Barmouth North OBC Review – Note these figures are updated by Appendix R which discussed phasing of the works see Section 2 of this review

Local Authority	Gwynedd County Council
Project Name	Barmouth North
Type of Report	OBC
Estimated Detailed Design Cost (£k)	£969k
Estimated Construction Cost with Optimism Bias (£k)	£23,238k (include ~£5m risk and ~£5m OB)
Optimism Bias (£k) (%)	26% (design and construction) 60% maintenance
Standard of Protection	1 in 50 in 2069 (>1 in 200 present day)
Number of Properties Protected	447 properties benefitting from scheme (390 residential/57 non-residential)
Benefit Cost Ratio	1 : 2.3
Wider Benefits	Protecting a stretch of the Cambrian Coastal Railway.
Proposed year for construction	2022
Potential Partners	██████████
Other Issues	Approval is requested for works to 2069 only, after this point the scheme reverts to Managed Realignment. The cost benefit ratio is based on the whole scheme. Gwynedd are currently proposing to split initial the works into 2 phases, structural works and beach nourishment works
Location	52.731262, -4.068191

Received Date	13/07/2021
Review Completed Date	04/11/2021
Approved	Yes
Name of Reviewer	██████████

Figure 24. Baseline Flood Depths (2019) Combined 1 in 200 year event

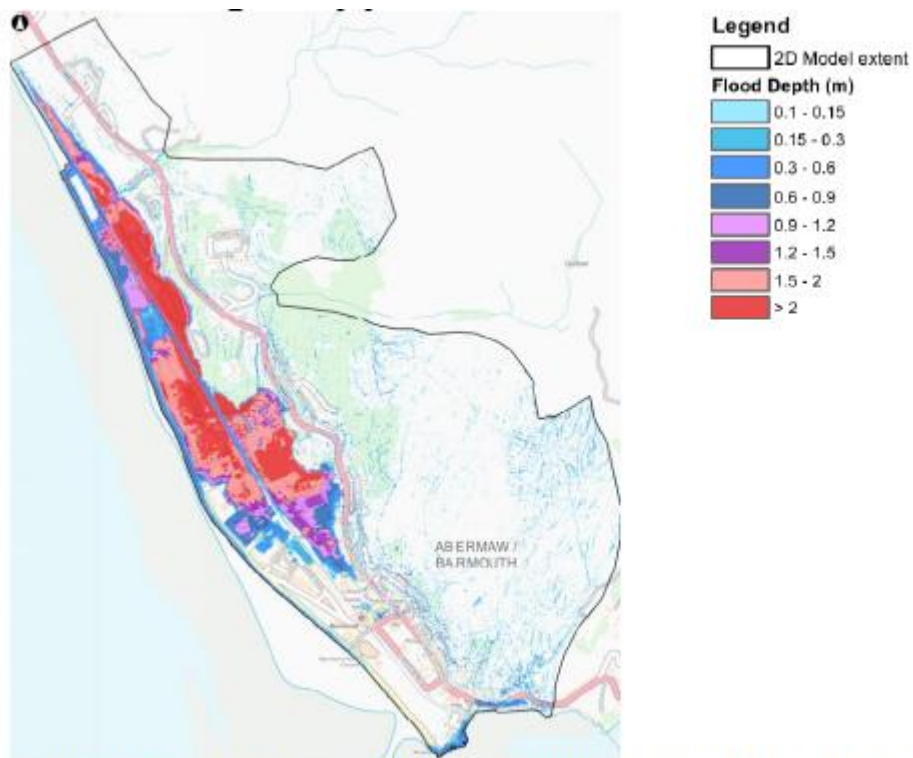
- Predicted rates of overtopping exceeded industry analytical methods and so modelling is only available for 2019 and 2069 epochs. The high degree of properties' value capping (due to the early onset of flooding) reduces the implication of this limitation on the business case.

Figure 1: Project typical sections and proposal for phasing (blue – Phase 1 split 1; yellow – Phase 1 split 2)

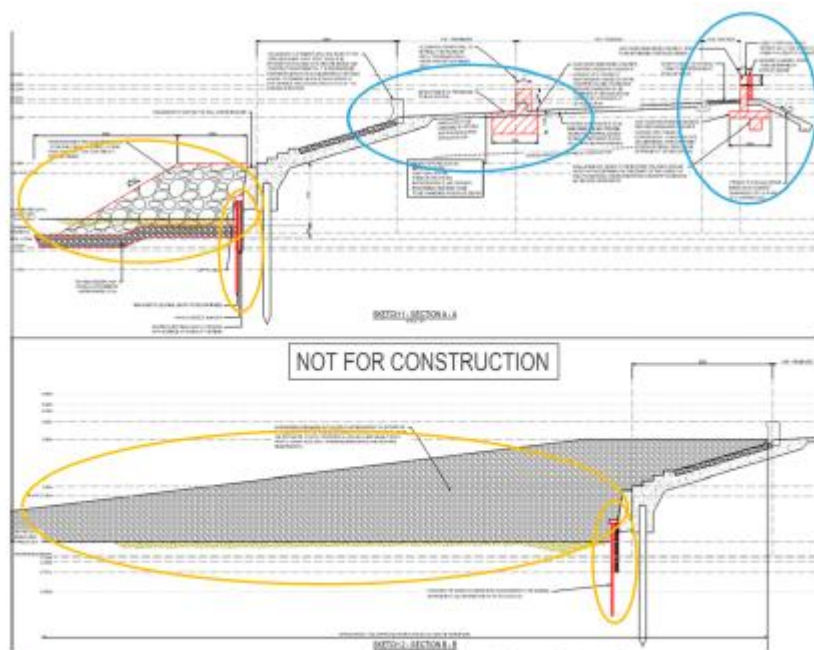
The strategic case is largely unchanged. High level risks have been split across the two stages. The risk of a damage to the new defences in advance of the beach works is not mentioned.
